CITY OF ALBUQUERQUE

**Re: Broadstone Promenade Phase 4
6400 San Pedro Dr. NE
Grading and Drainage Plan
Permanent CO – Accepted
Engineer's Stamp dated: 5-26-15 (D18D054A)
Certification dated: 9-28-15**

I, Fred C. Arfman, NMPE 7322, Genevieve L. Donart NMPE 15088 or Asa Nilsson-Weber, NMPE 17631 of the firm Isaacson & Arfman, P.A., hereby certify that this project has been graded and will drain in substantial compliance with and in accordance with the design intent of the approved plan dated May 26, 2015; Grading And Drainage Plan CG1.1-CG1.4. The record information edited onto the original design document has been obtained by Russ P. Hugg, NMPS 9750, of the firm Surv-Tek, Inc. I further certify that I or someone under my direct supervision have personally visited the project site at various times as documented below and have determined by visual inspection that the survey data provided is representative of actual site conditions and is true and correct to the best of my knowledge and belief. This certification is submitted in support of a request for Permanent Certification of Occupancy for those individual buildings listed below.

OVERALL
GRADING AND DRAINAGE PLAN

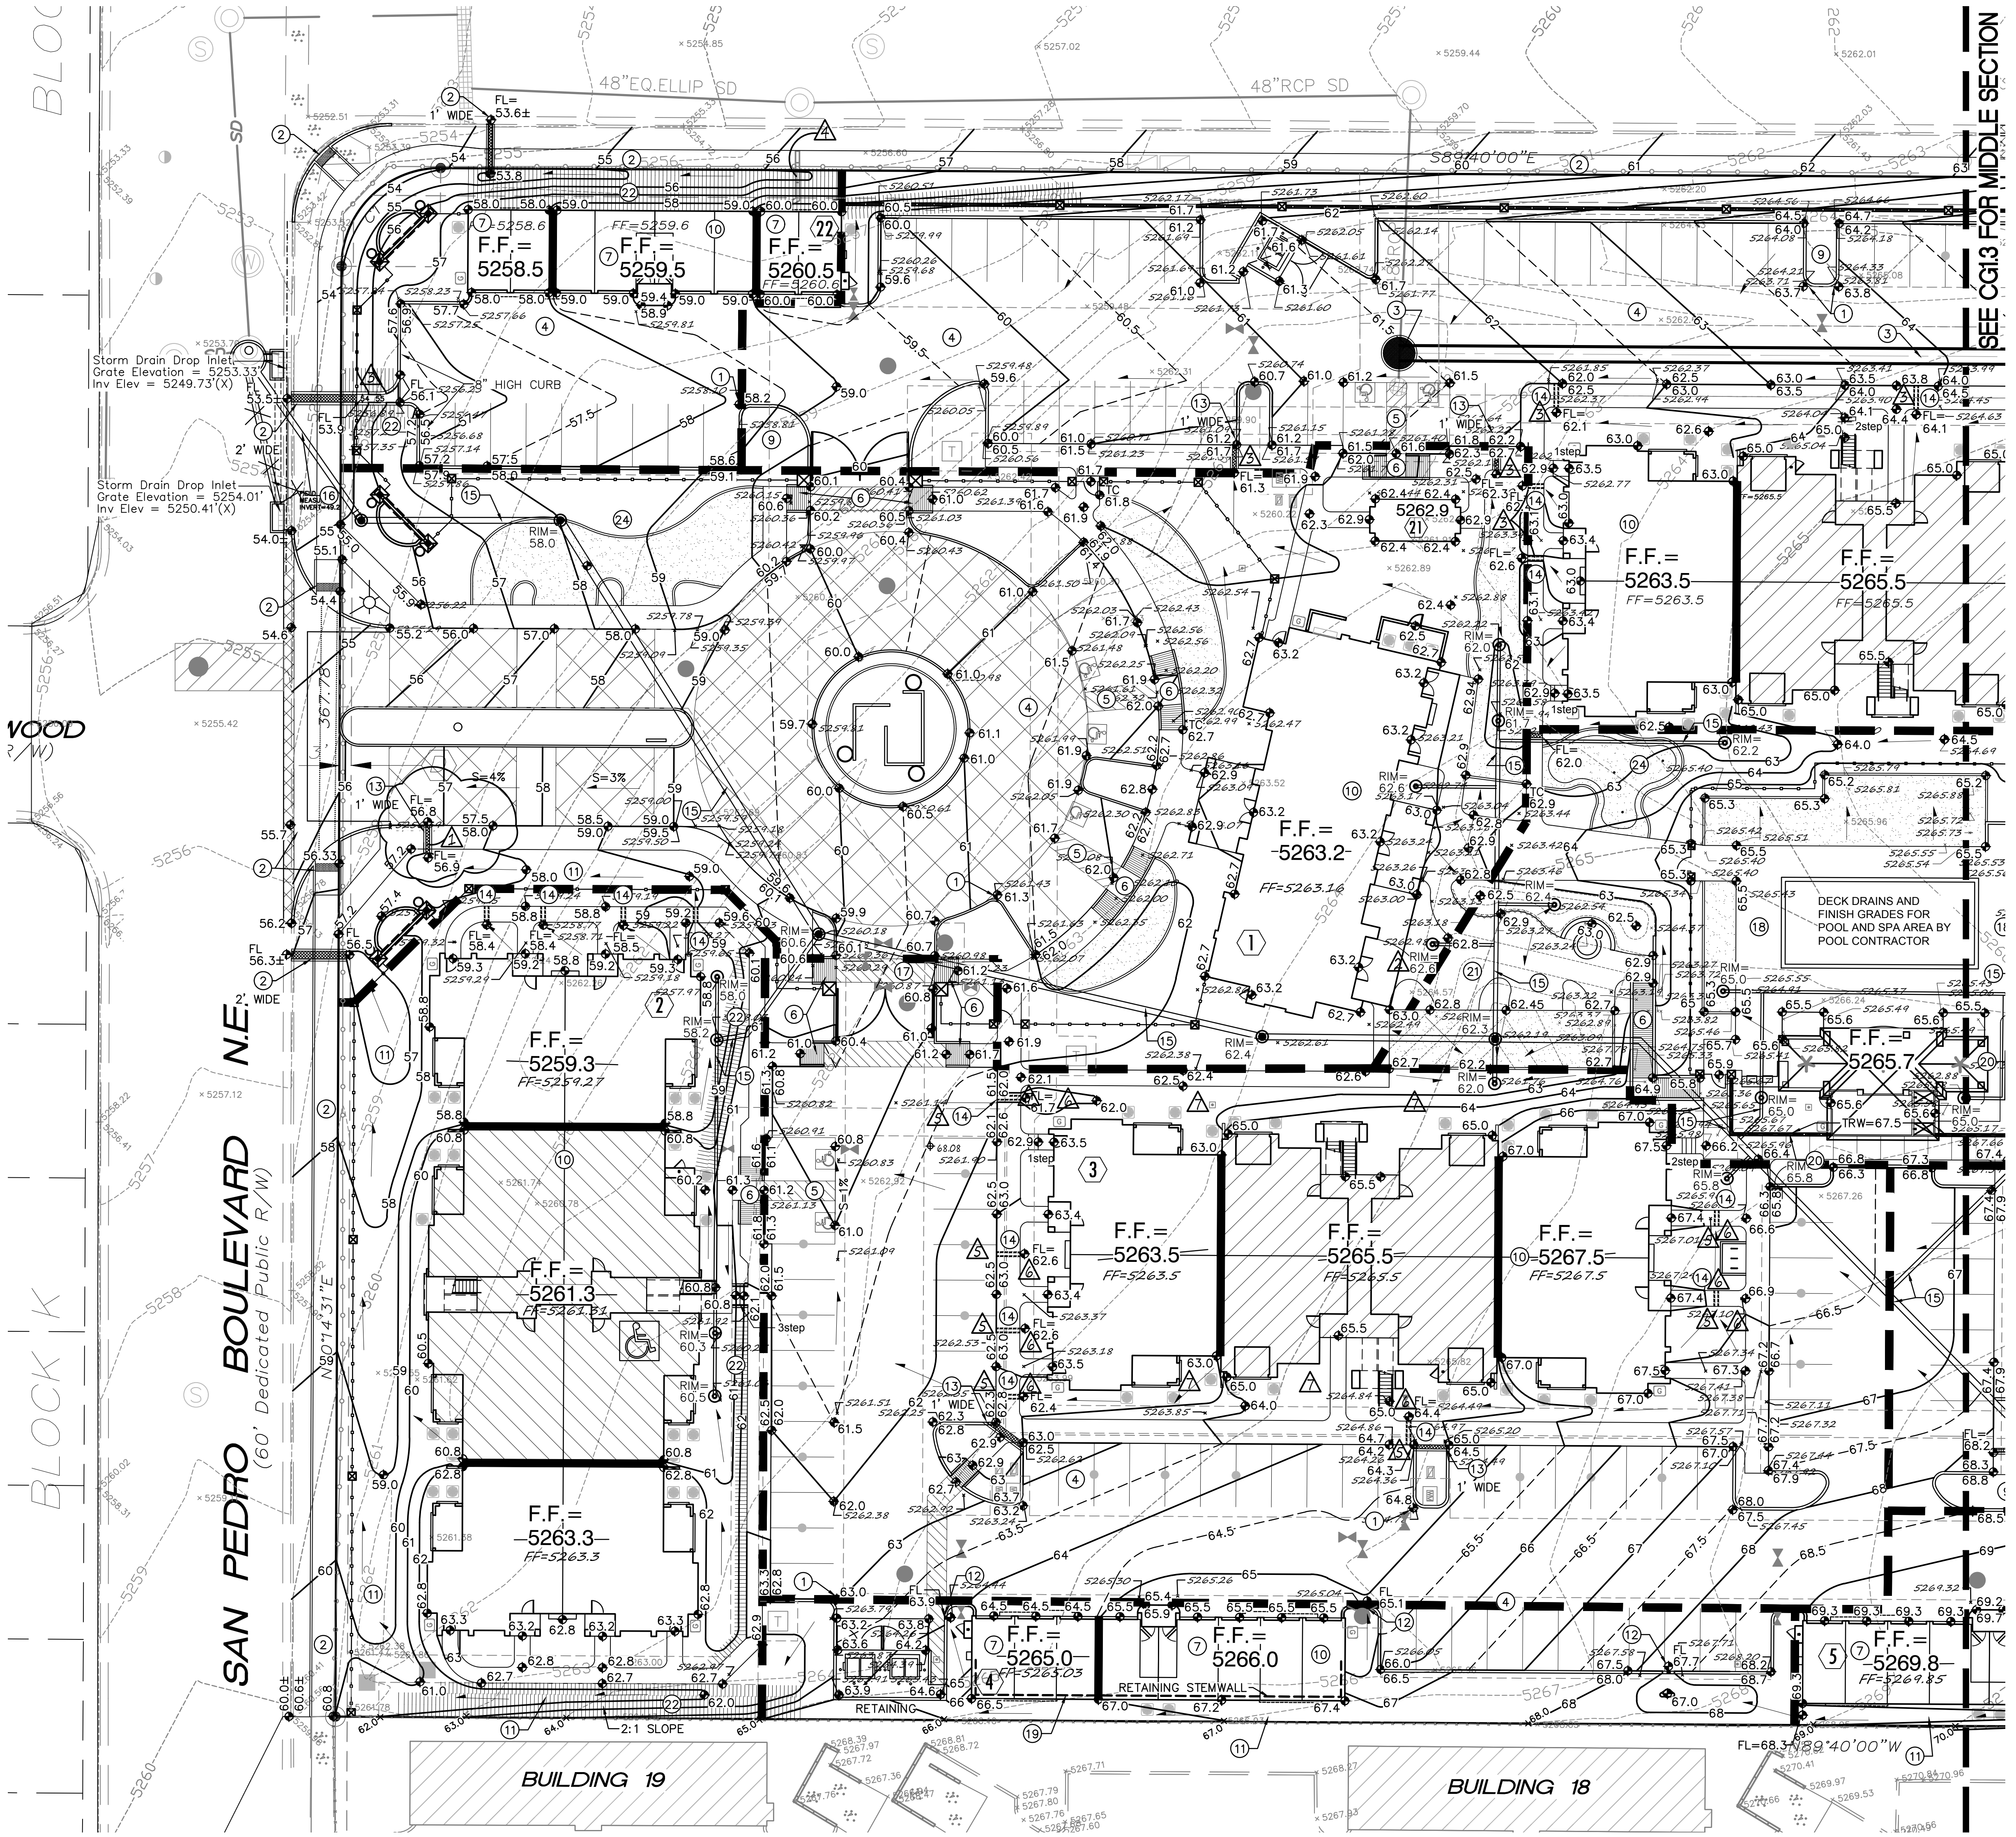
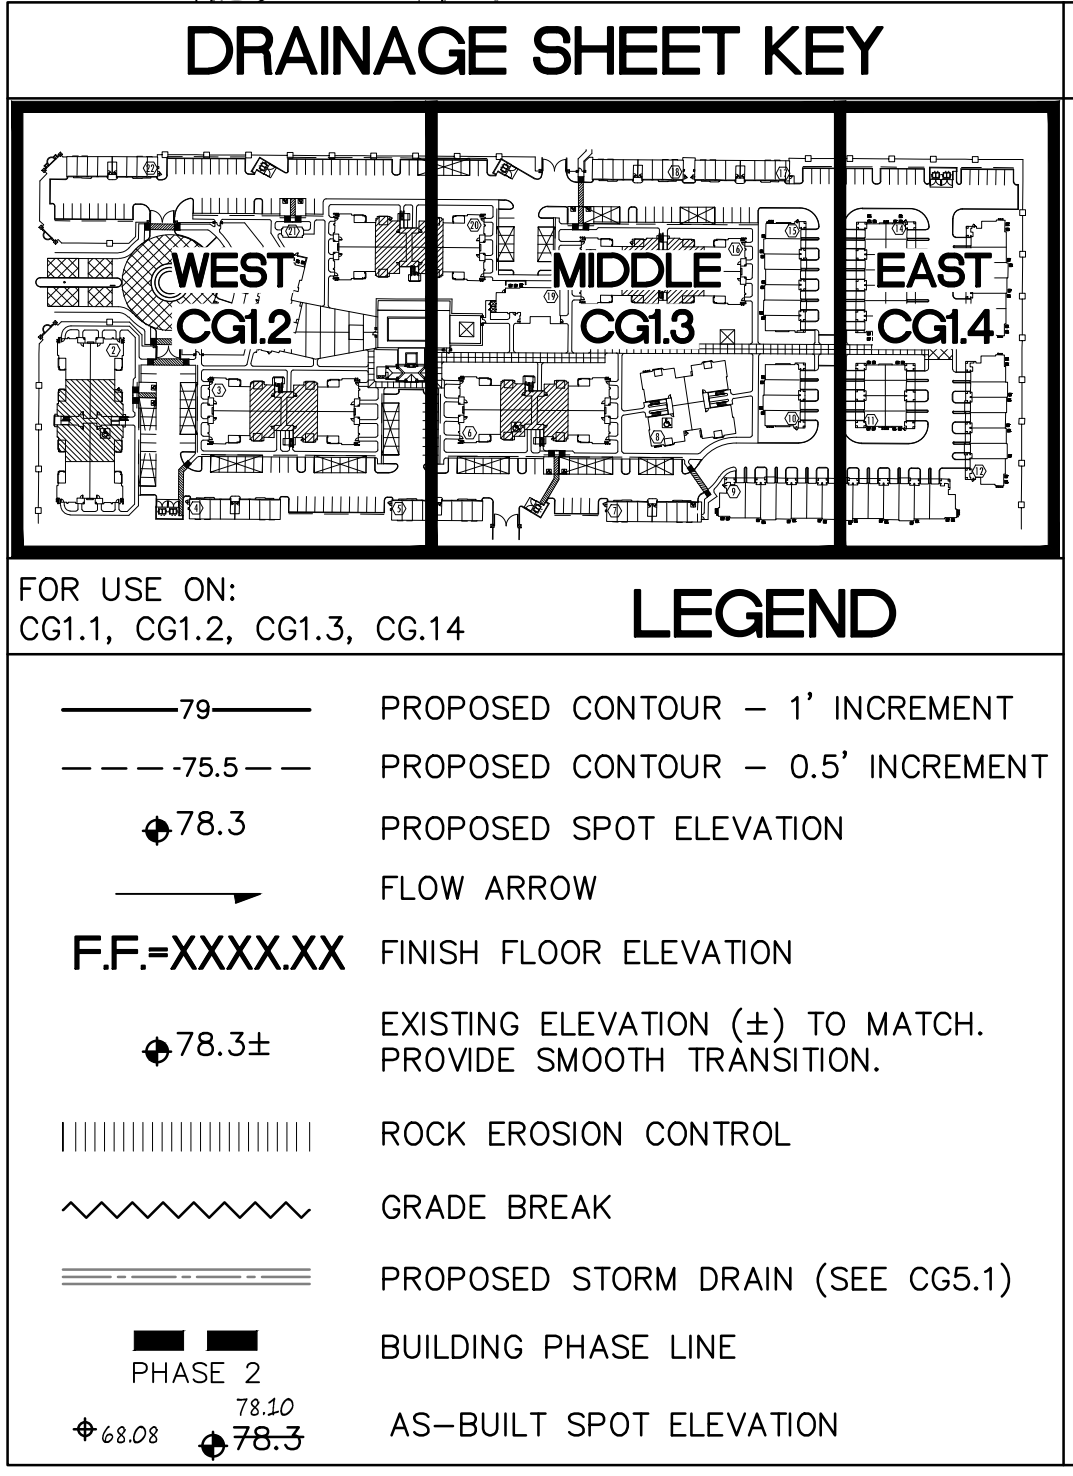
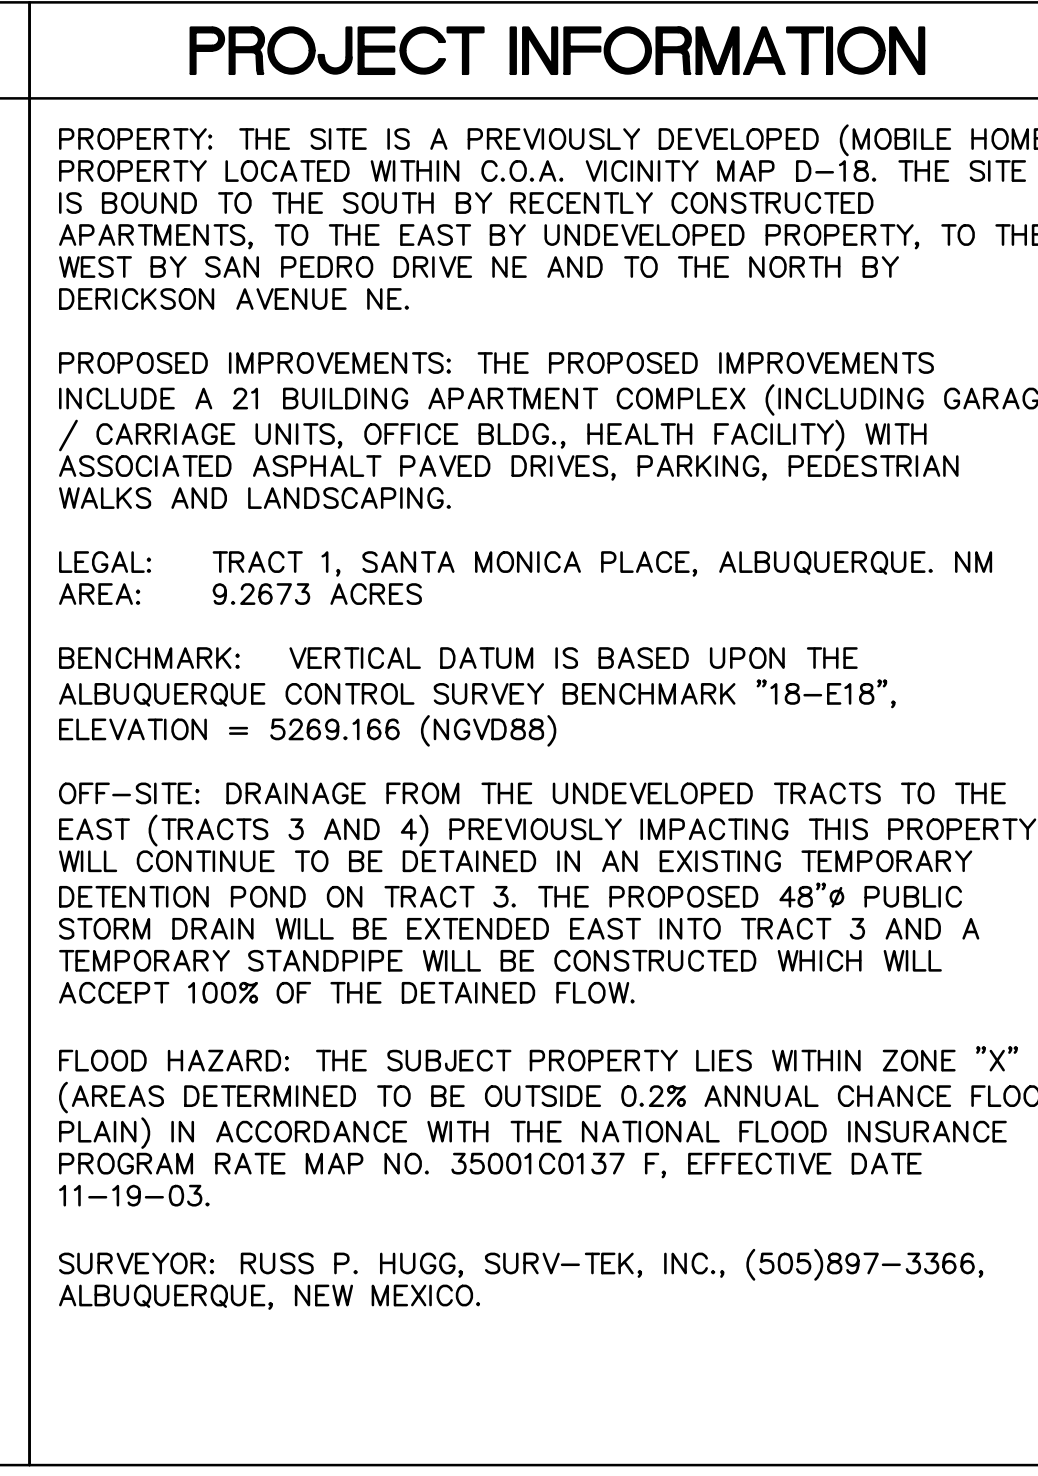
NOTES:
PHASE 1:
SIDEWALK CULVERT NOT CONSTRUCTED. CULVERT SHALL BE CONSTRUCTED PRIOR TO CERTIFICATION OF BUILDING 2.

PHASE 2:
LOWER/ADJUST STORM DRAIN GRATES TO GRADE. TO BE VERIFIED PRIOR TO CERTIFICATION OF PHASE 3.

PHASE 3:
INSTALLATION OF SIDEWALK CULVERT OR PVC PIPES TO BE VERIFIED PRIOR TO CERTIFICATION OF PHASE 4.

PHASE 5:
GRADING OF SLOPE TO BE VERIFIED PRIOR TO CERTIFICATION OF PHASE 4.

PHASE 4:
COMPLETION OF ITEMS FROM PHASES 3 & 5 TO BE VERIFIED PRIOR TO FINAL CERTIFICATION.

INSTALLATION OF 4" PVC PIPES TO BE VERIFIED PRIOR TO FINAL CERTIFICATION.

LANDSCAPING TO BE ADJUSTED SUCH THAT A SWALE DIRECTS STORM WATER TO PIPES OR SIDEWALK CULVERTS AND THAT TOP OF MATERIAL IS AT INVERT OF PIPE OR CULVERT TO ALLOW FOR FLOW THROUGH. UNDER NO CIRCUMSTANCES SHOULD THE ENDS OF PIPES OR CULVERTS BE BURIED. THIS SHALL BE VERIFIED PRIOR TO FINAL CERTIFICATION.

OBTAIN ADDITIONAL AS-BUILT SPOTS TO ALLOW FOR VERIFICATION OF DRAINAGE PATHS AND SLOPES PRIOR TO FINAL CERTIFICATION.
